Addendum 1 for RFB921500-01

Project Name: Grimes Lighting Replacement
DAS RFB #: 921500-01
DAS Project #: 9215.00
Date: 09/03/2021

State of Iowa Capital Complex
Grimes Office Building Lighting
Addendum #1
September 3, 2021

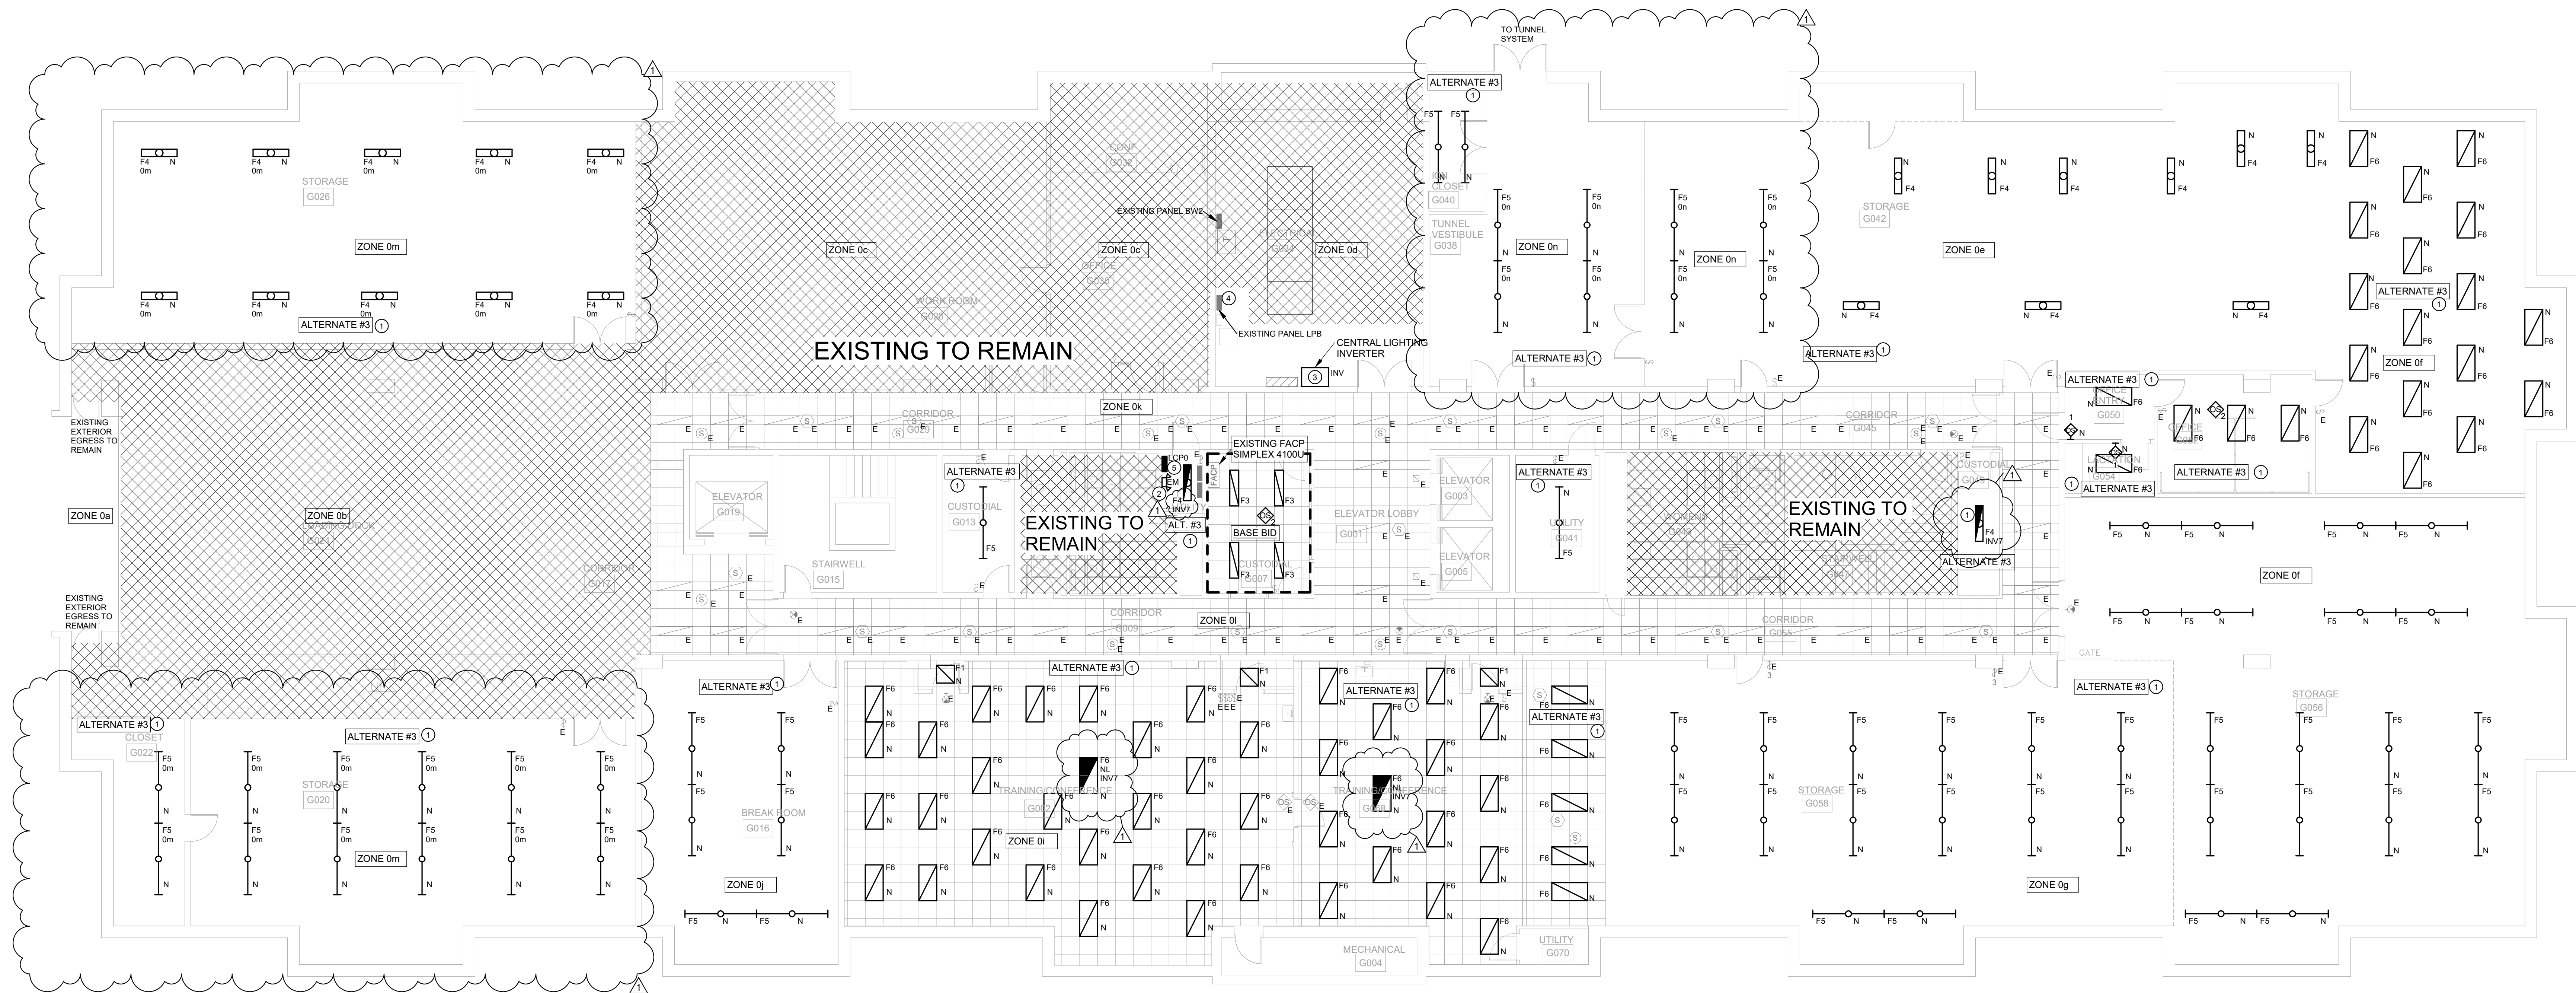
2. E100 - Electrical Lighting Basement
 - a. **ADD** Lighting control zone for storage room G020, G022, G026.
 - b. **ADD** Lighting control zone for Tunnel Vestibule G038 and south side of Storage G042.

- c. **ADD** control zone tags to Emergency light fixtures for dimming capabilities.
 - d. **ADD** Emergency light fixtures in the conference rooms.
 - e. **ADD** Emergency light fixtures on Inverter circuit #7.

- f. Refer to attached full size sheet E100.
3. E101 - Electrical Lighting First Floor
 - a. **ADD** Emergency separators and relay descriptions to relay schedule for control of emergency light fixtures.

Drawing #:
E101

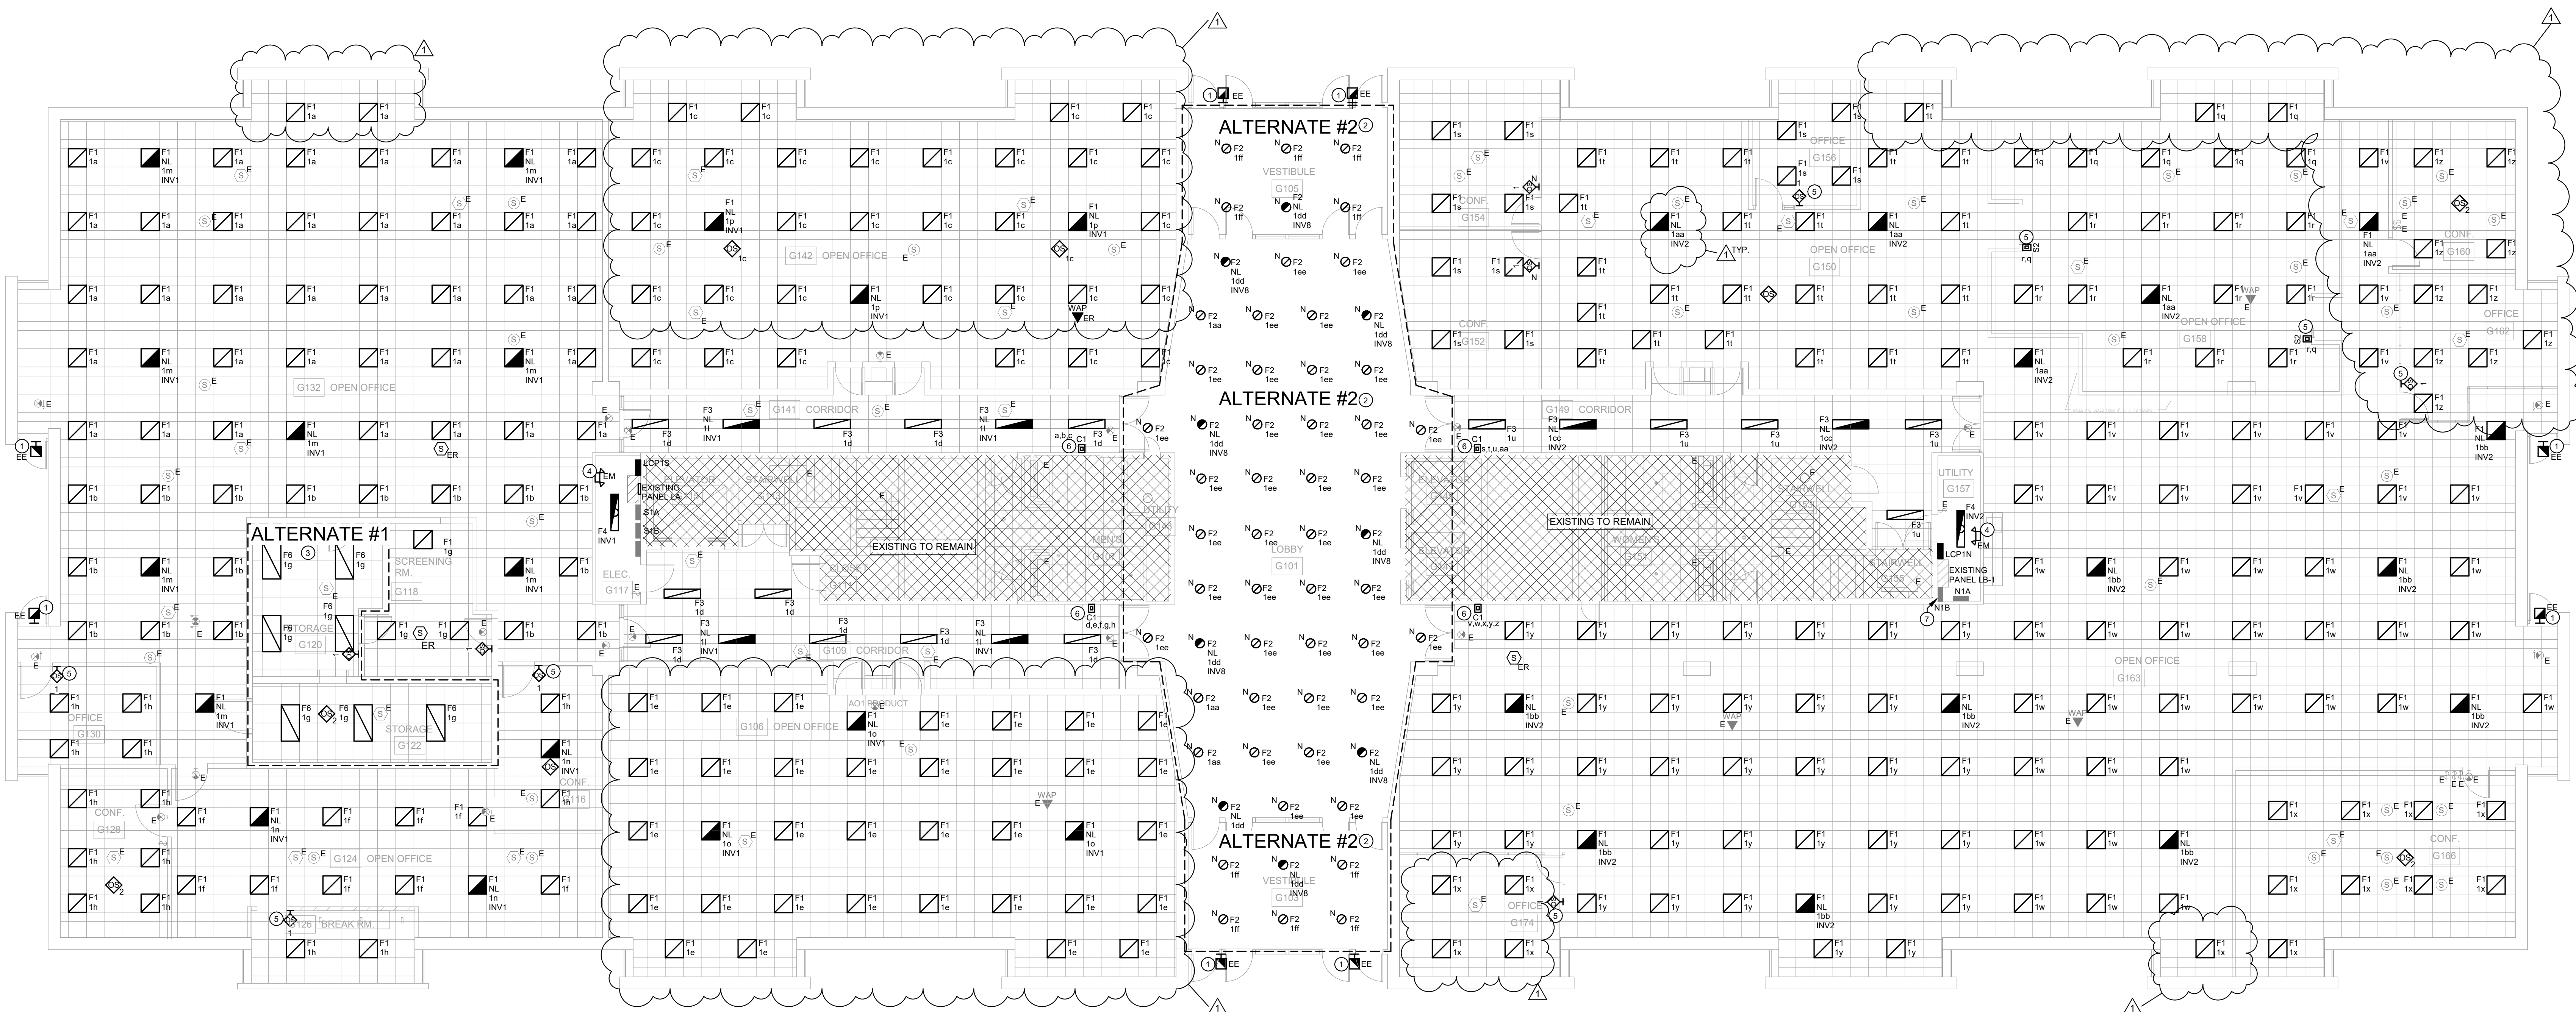
- b. **ADD** control zone tags to Emergency light fixtures for dimming capabilities.
 - c. **ADD** “F1” light fixtures to bump out locations near exterior walls.

- d. **ADD** “F1” light fixtures in G106 Open Office.
 - e. **REVISE** Emergency lighting in G142 Open Office.
 - f. **ADD** circuiting of local unswitched lighting circuit to Lighting control panels to provide loss of power sense for emergency override capability.

- g. **ADD** keynote #7 for revision of lobby and vestibule lighting circuit breaker.
 - h. Refer to attached full size sheet E101.

Drawing Name:
ELECTRICAL LIGHTING
SECOND FLOORDrawing #:
E1021 SECOND FLOOR LIGHTING
1/8" = 1'-0"

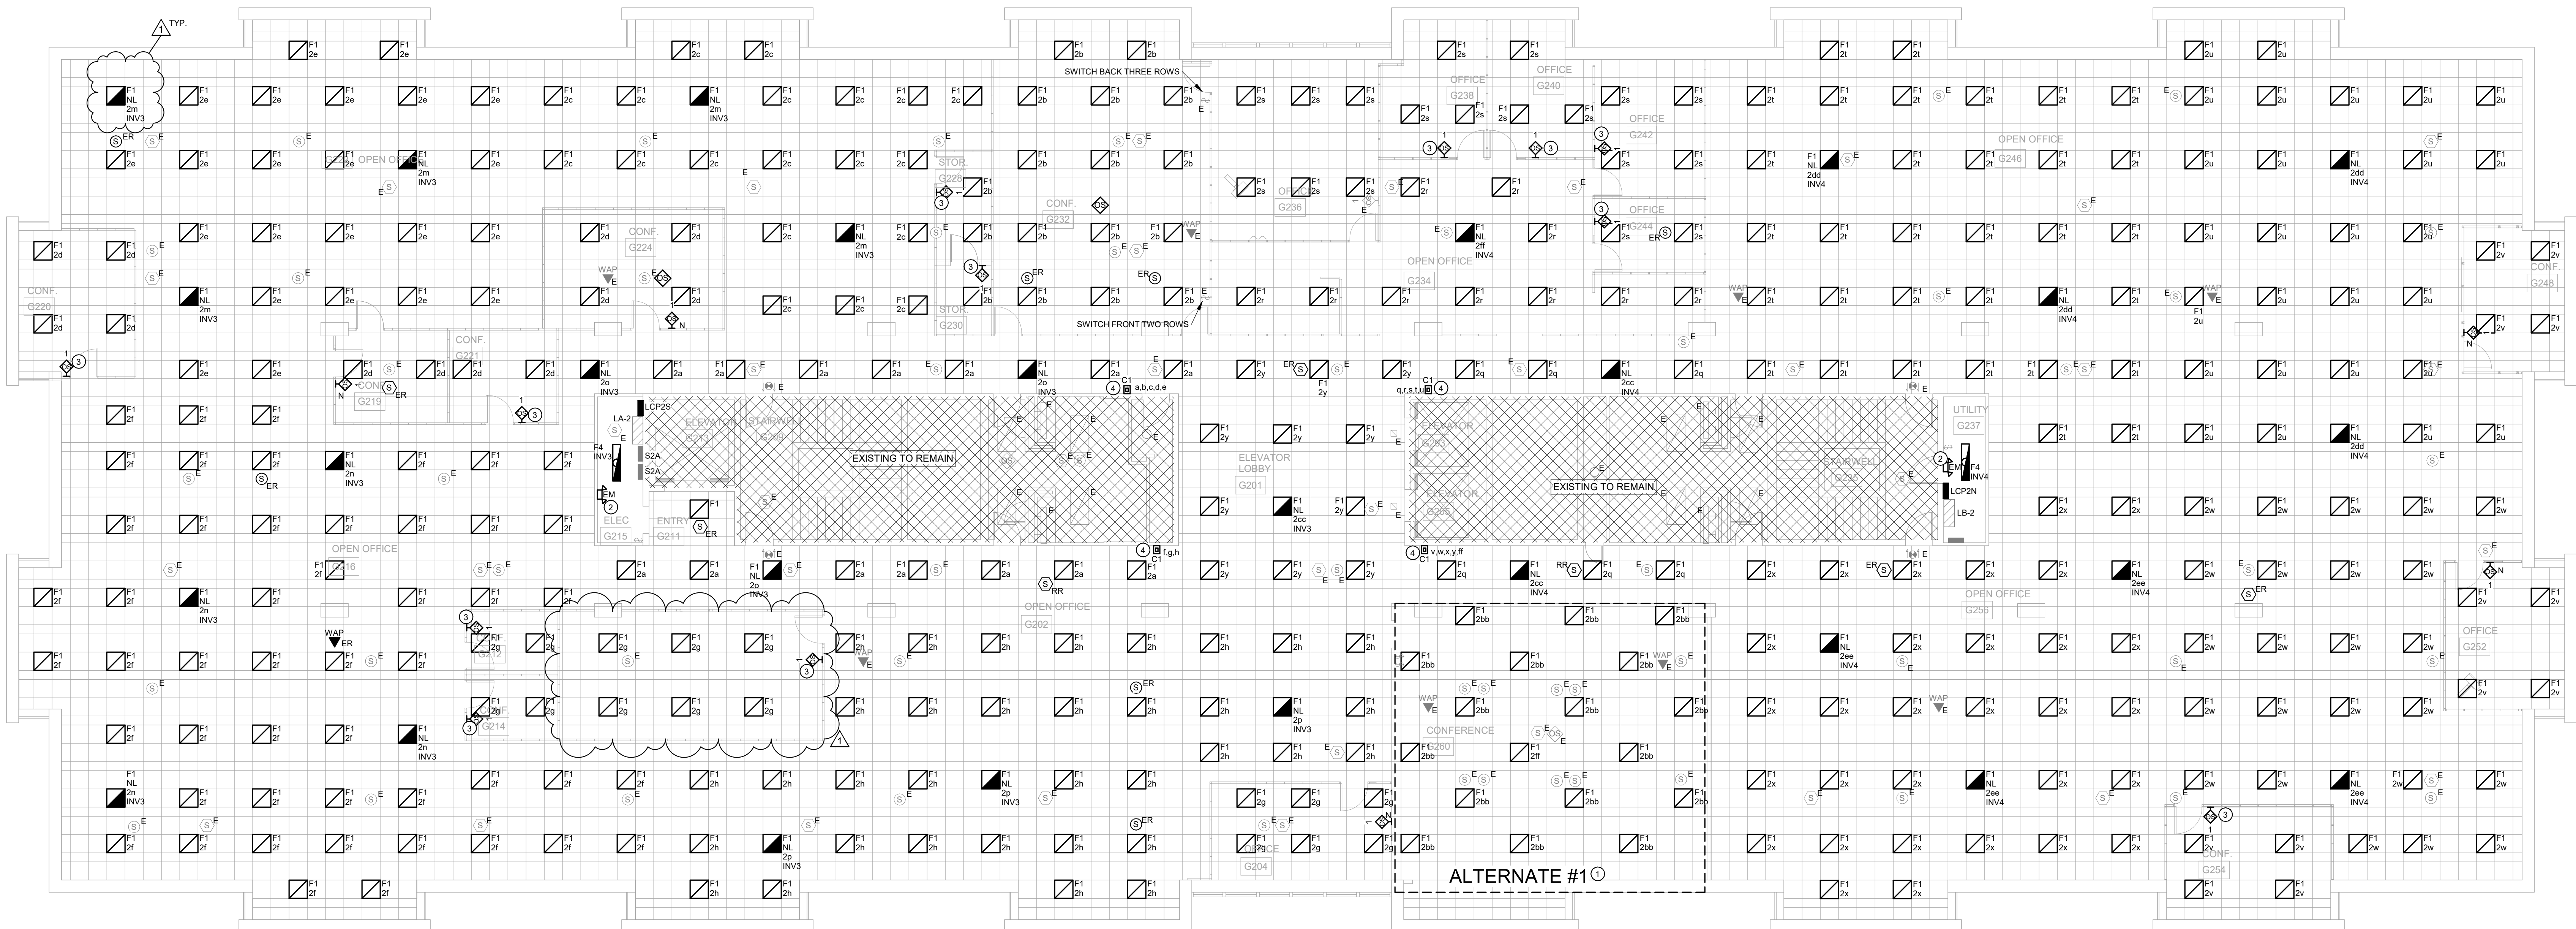
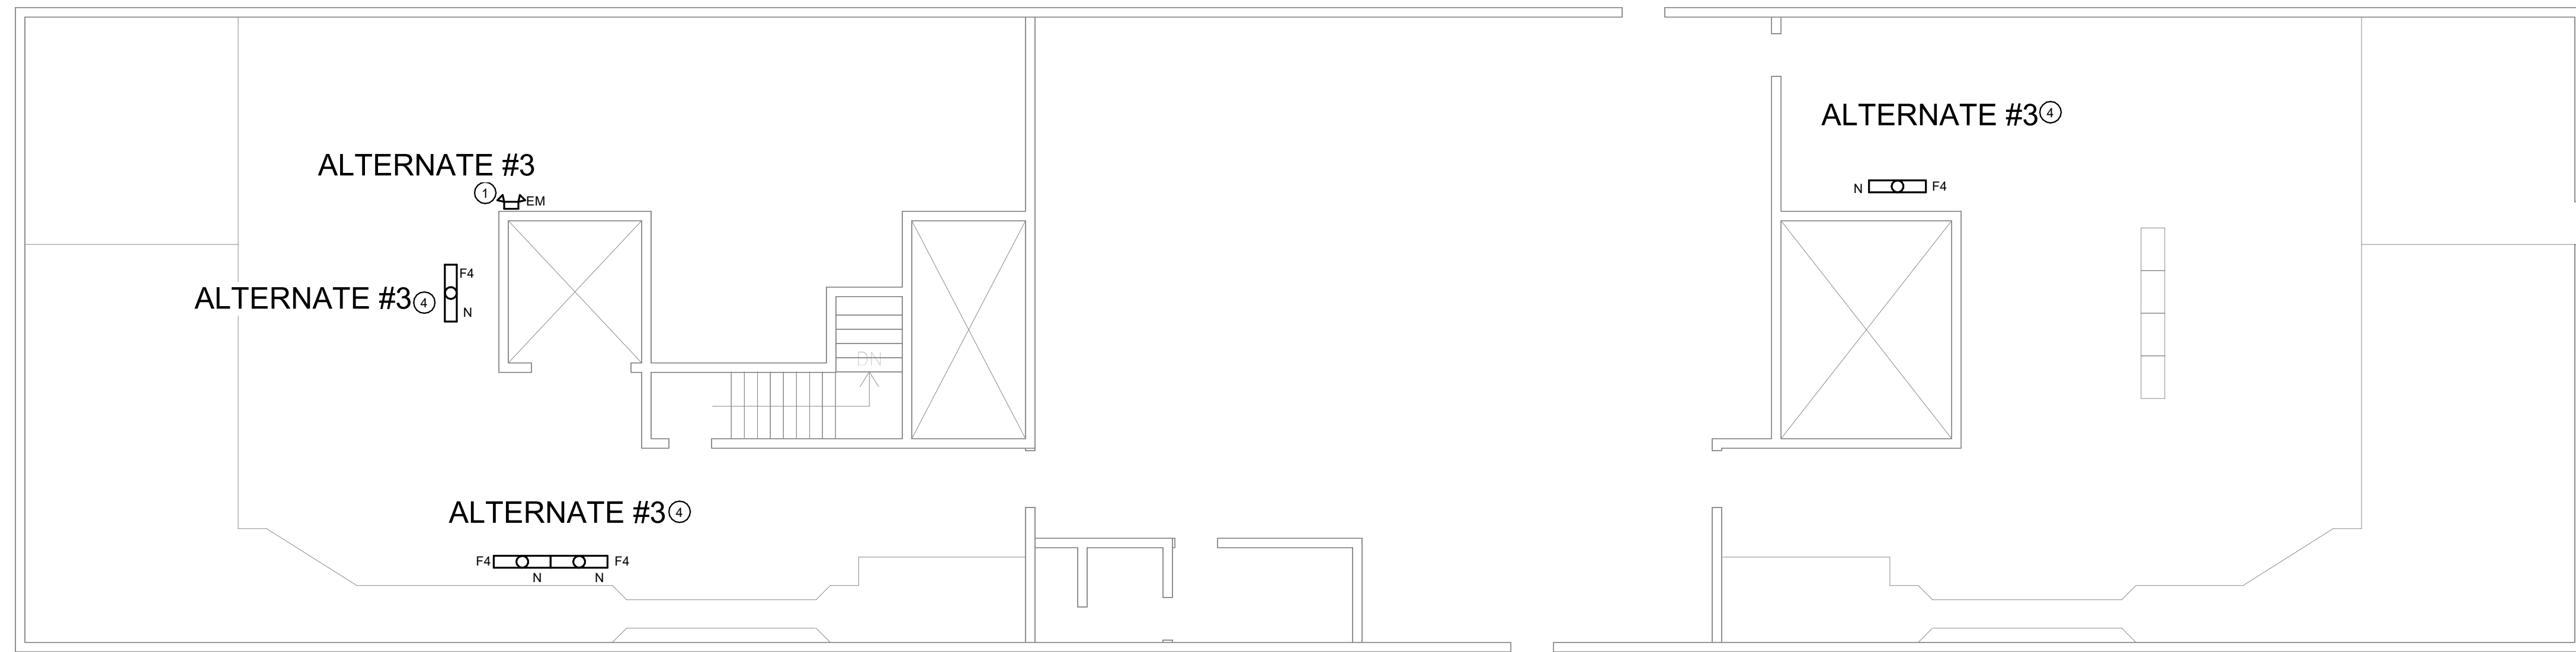
4. E102 - Electrical Lighting Second Floor
 - a. **ADD** Emergency separators and relay descriptions to relay schedule for control of emergency light fixtures.

- b. **ADD** control zone tags to Emergency light fixtures for dimming capabilities.
 - c. **ADD** circuiting of local unswitched lighting circuit to Lighting control panels to provide loss of power sense for emergency override capability.

- d. **REMOVE** (2) "F1" fixtures from storage room.
 - e. Refer to attached full size sheet E102.
5. E103 - Electrical Lighting Third Floor and Penthouse
